This document was generated in response to a request for additional technical information by Tim Johnson of AmericanTCB, in regards to the Permissive Change (Class II) approval of the model 5135. The information included in 10 specific topics discussed in the following email received by Lin Lu on March 3, 2003:

From: Tim Johnson <tjohnson@americantcb.com>
To: "llu@kyocera-wireless.com" <llu@kyocera-wireless.com>
Cc: Tim Johnson <tjohnson@americantcb.com>
Subject: Review of OVFKWC-5135 Permissive Change Application
Date: Mon, 3 Mar 2003 09:38:55 -0500
X-Mailer: Internet Mail Service (5.5.2653.19)
X-BigFish: cs-60(zzaf6R7eeRd74Md75Mzzzzz1IV)v

Dipole 835MHz

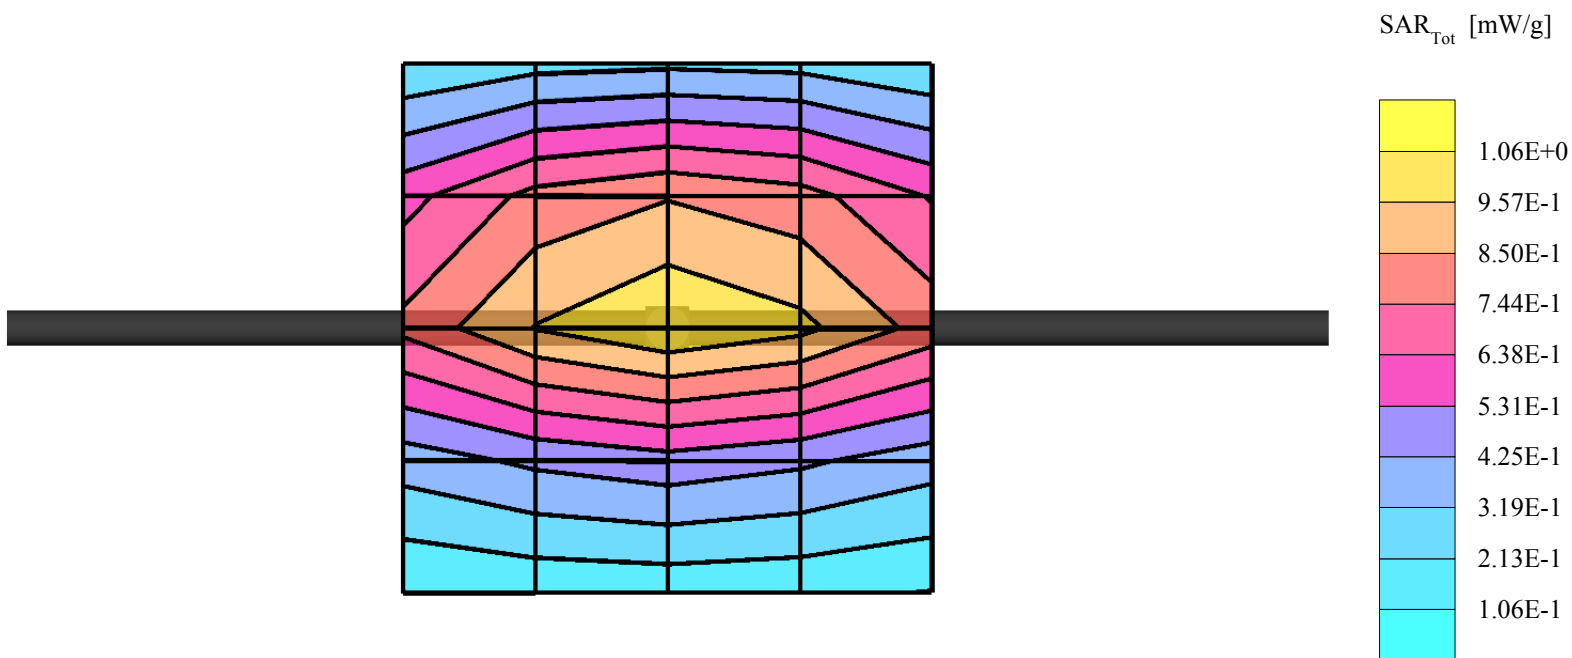
- 6) Dipole verification plots are missing for testing performed in 1/9/03 for 835 MHz. Please provide.

The dipole verification plot for testing performed in 1/9/03 is provided in the proceeding page.
